Service Bulletin

No. : MZ08-043

Model: PM5003

Subject: The protection operation cannot be deactivated.

<Measure 1: Clear the protection operation procedure programmed in the RAM>

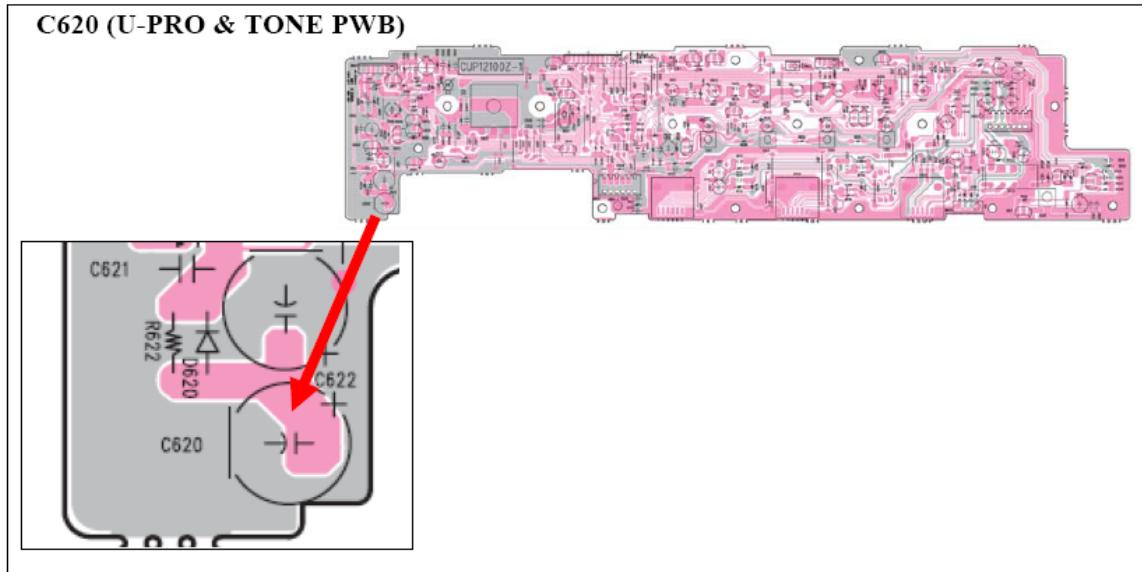
Symptom: The protection operation cannot be deactivated by the Power Switch being turned OFF/ON. If a problem is detected while the AMP is in operation, the STANDBY LED starts flickering and the operation is ceased. If the problem is no longer detected, the protection operation can be normally deactivated by turning the power OFF and then ON. However, in this case, the STANDBY LED cannot be stopped from flickering, depending on the timing of the power switch being turned OFF/ON.

Solution: As a remedy for this phenomenon, either of the following two measures can be taken. Please check the situation and determine which to take.

- Clear the protection operation procedure in the RAM by shorting the backup capacitor C620. After deactivating the protection operation, ensure that none of "DC Offset", "DC Balance" and "Over current" (Speaker Short-out) is detected.
- If no abnormality is found with the amp, the protection operation may have been activated by over current caused by a shot-out of the speaker cable. Before returning the repaired unit, please be sure to check how it was used to a customer.

- The backup capacitor is capable of storing data in the RAM for up to one week. If the unit comes in for repairs more than one week after the phenomenon has occurred, please understand that no pertinent data may be available for the phenomenon.
